William R. Gideon
Vice President
Brunswick Nuclear Plant
P.O. Box 10429
Southport, NC 28461

Serial: BSEP 17-0093

Subject: Brunswick Steam Electric Plant, Unit Nos. 1 and 2
Renewed Facility Operating License Nos. DPR-71 and DPR-62
Docket Nos. 50-325 and 50-324
Response to Request for Additional Information Regarding Request for License
Amendment Regarding Core Flow Operating Range Expansion (CAC
Nos. MF8864 and MF8865)

Response to Request for Additional Information

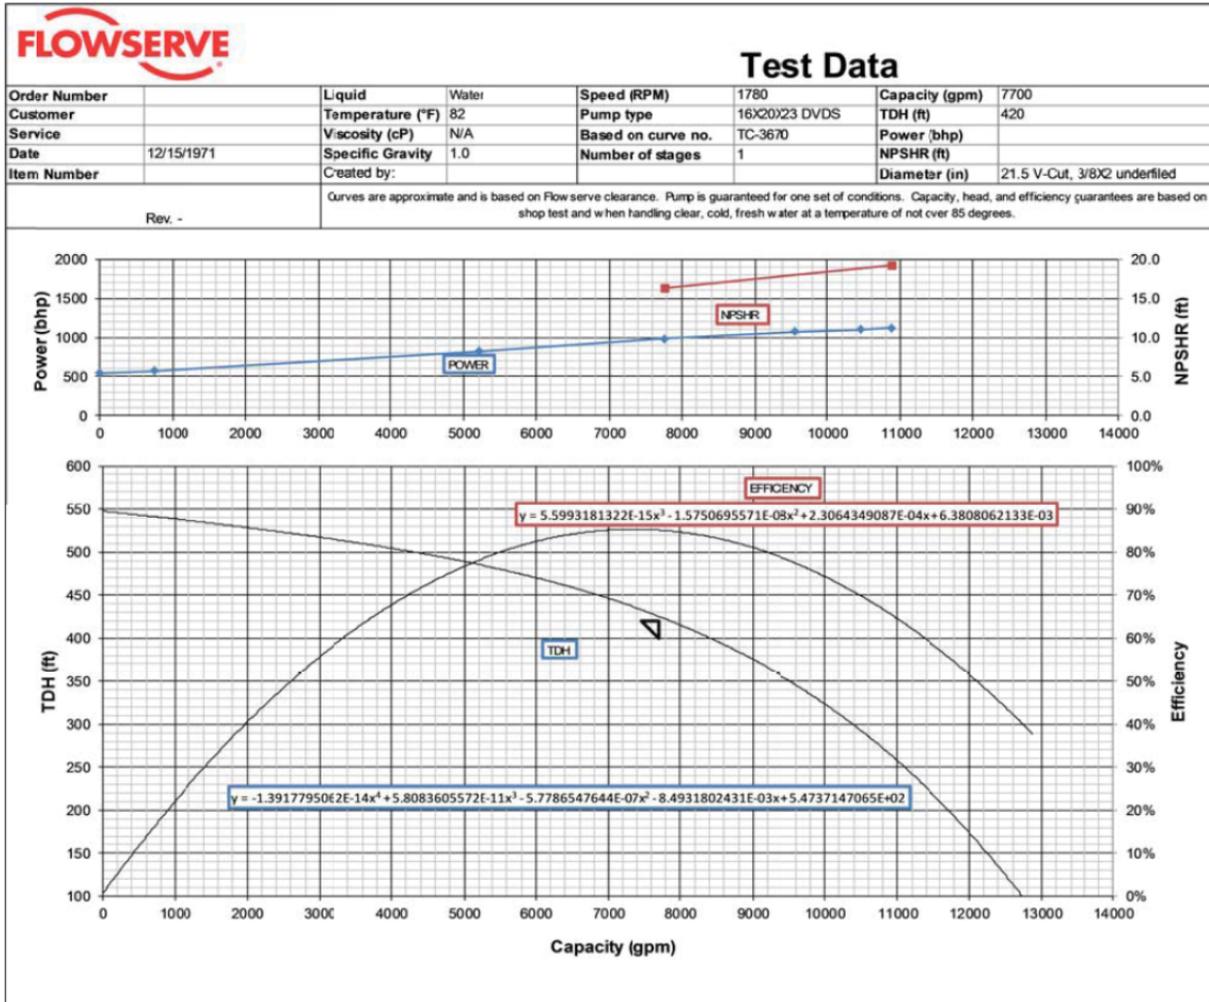
Provide the pump manufacturer's input, such as test reports, including the basis for qualifying the RHR pumps to operate satisfactorily while cavitating without any damage with the short term (<600 sec from LOCA initiation) flow rate of 21,100 gpm.

In the NPSH analysis prepared for the SECY 11-0014, the limiting NPSH condition occurs with two RHR pumps delivering flow at maximum flow conditions during the short term (< 600 seconds) phase of the DBA-LOCA. No operator action or Containment Accident Pressure (CAP) is credited during this period. In this limiting scenario, in the short term (< 600 seconds), the flow from both pumps is lost out of the break (piping failure) and no credit for core or containment cooling is assumed. The analysis results indicate that NPSHA is less than $NPSHR_{eff}$ for approximately 400 seconds (from 213 seconds to 600 seconds).
